Technical Service Information

FORD AXOD-E REDESIGNED REAR LUBE CROSS LUBE TUBE SEAL AND REAR PLANETARY SUPPORT

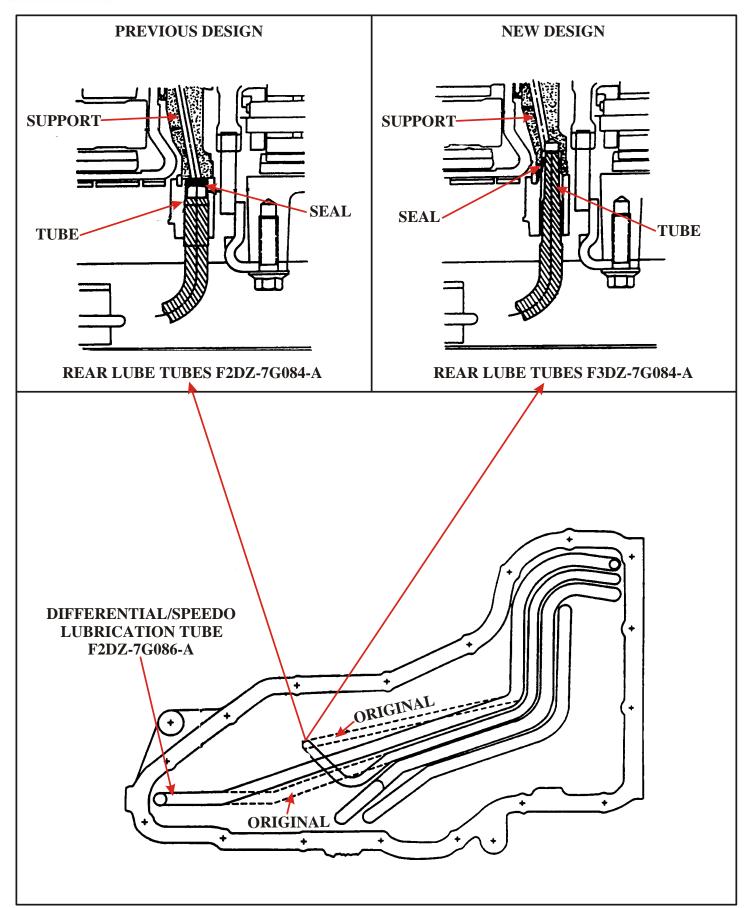
The Rear Lube Cross-Over Tube, Lube Tube Seal, and the Rear Planetary Support have been redesigned beginning in mid-year 1993 and introduced as a running change in model year 1993.

- (1) REAR LUBE CROSS-OVER TUBE Has a longer, smaller diameter end to pass completely through the case and INTO the revised lube seal, which is low pressed into the new rear planetary support (See Figure 1).
- (2) RFARLUBETUBESEAL Now pressed into the new rear planetary support to accommodate the new rear lube cross-over tube (See Figure 2).
- (3) REAR PLANETARY SUPPORT Now bored to accept the new rear lube tube seal (See Figure 2)

- (1) The redesigned parts listed above ARE NOT interchangeable with previous design level parts.
- (2) The redesigned parts listed above may be used on any 1991 or 1992 AXOD-E transaxle, however ALL THREE PIECES MUST BE USED TOGETHER.
- (3) The redesigned parts listed above CANNOT be used on 1986-1990 AXOD transaxles, because of the governor circuit.
